**TOWN OF WELLINGTON
PLANNING COMMISSION**

**May 3, 2021
6:30 PM**

Date: May 3, 2021
Submitted By: Cody Bird, Planning Director
Subject: Site Plan Review - 3700 Cleveland Ave.

Date: May 3, 2021
Submitted By: Cody Bird, Planning Director
Subject: Site Plan Review - Lot 1, Block 6, Wellington (3749 Harrison Ave.)

LANDSCAPE PLAN
SCALE: 1" = 10'

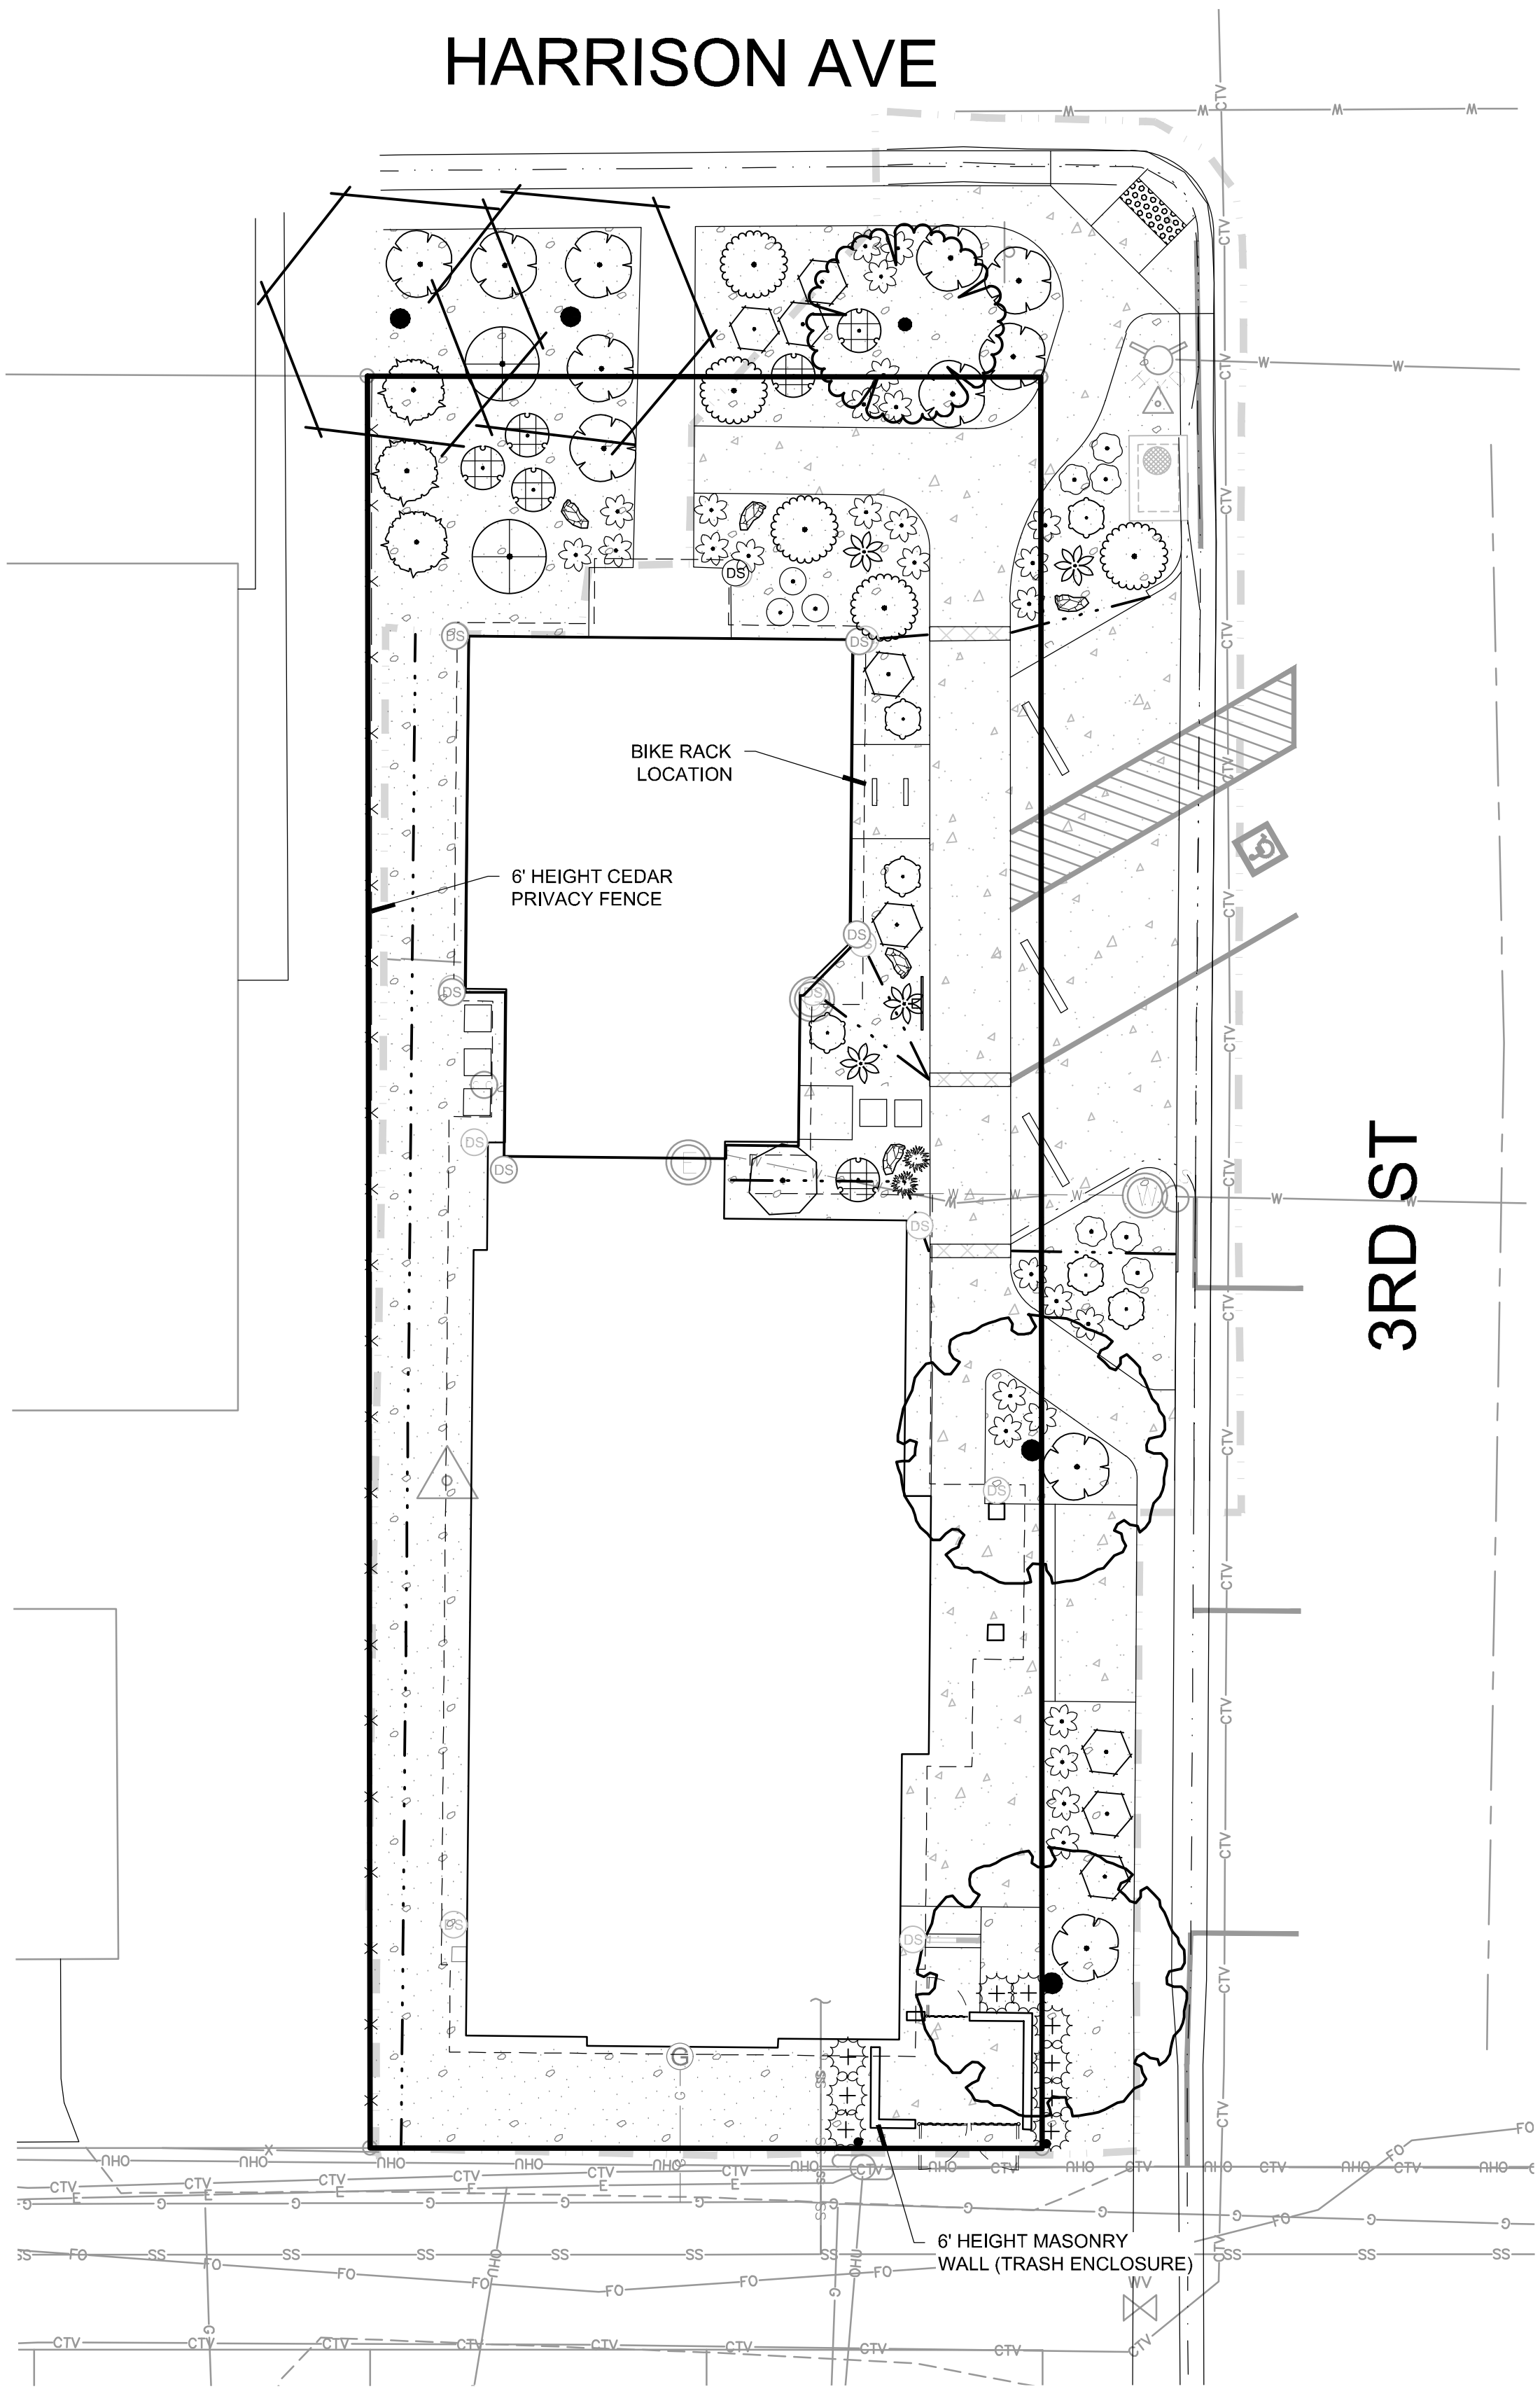
10. Landscape/Screening and Buffering: The applicant submitted a landscaping plan as required. Most of the existing trees on or adjacent to the site are proposed to be removed due to condition or to make way for the proposed building. Any trees that are proposed to remain on site should be protected during construction.

- Parking Lot Trees/Shrubs/Screening:
- No parking lot trees are proposed for this site plan.
- The trash enclosure and electrical transformer are proposed to be screened with grasses. Applicant must ensure the grass height will adequately screen and not impede any service providers from accessing this equipment.

- Plant species proposed are low-water varieties. Irrigation needs will be satisfied using potable water.

PHOTOMETRIC SITE PLAN - ELECTRICAL

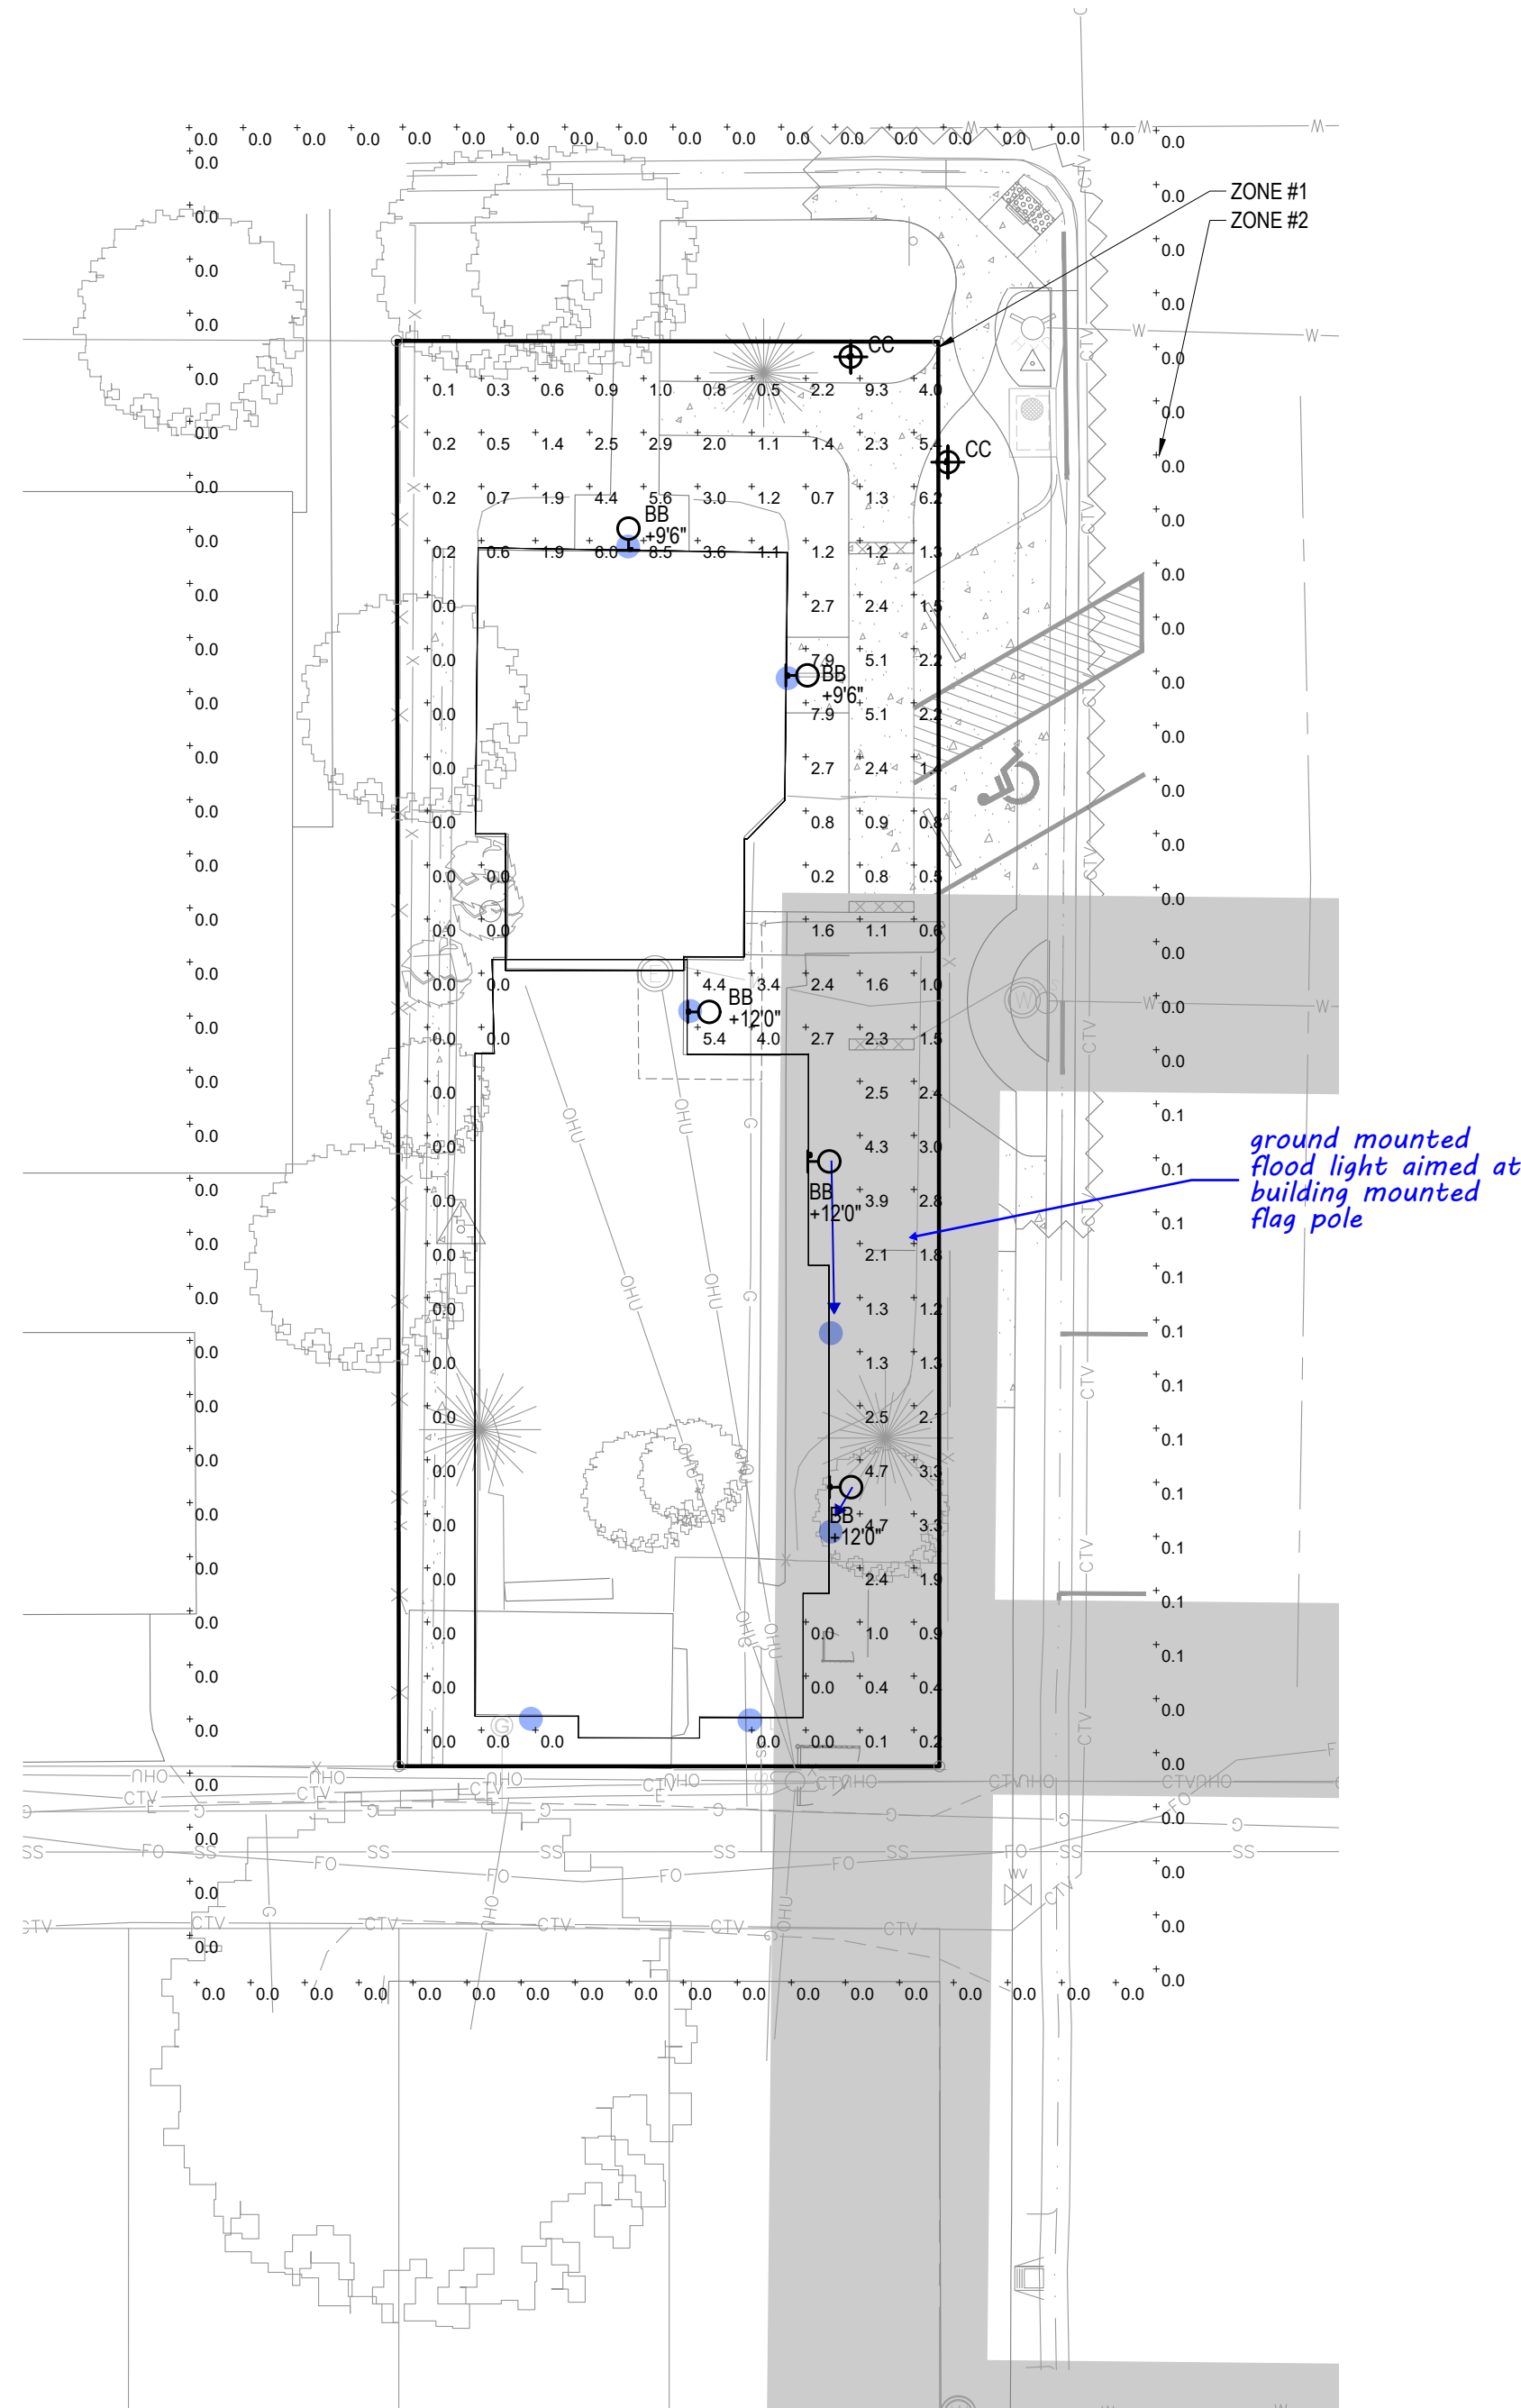
9. Site Lighting: A photometric plan was provided with the site plans as required. The Town's maximum illumination level at the property line is 0.1 footcandle. Locations along the north, east, and southern boundaries are shown to be slightly over the 0.1 maximum illumination. Additionally, the Town has a minimum illumination level of 1.0 footcandle for parking areas and pedestrian paths. The slightly higher illumination levels at the property lines may be found to be acceptable because the lighting may help illuminate the sidewalks and parking areas.
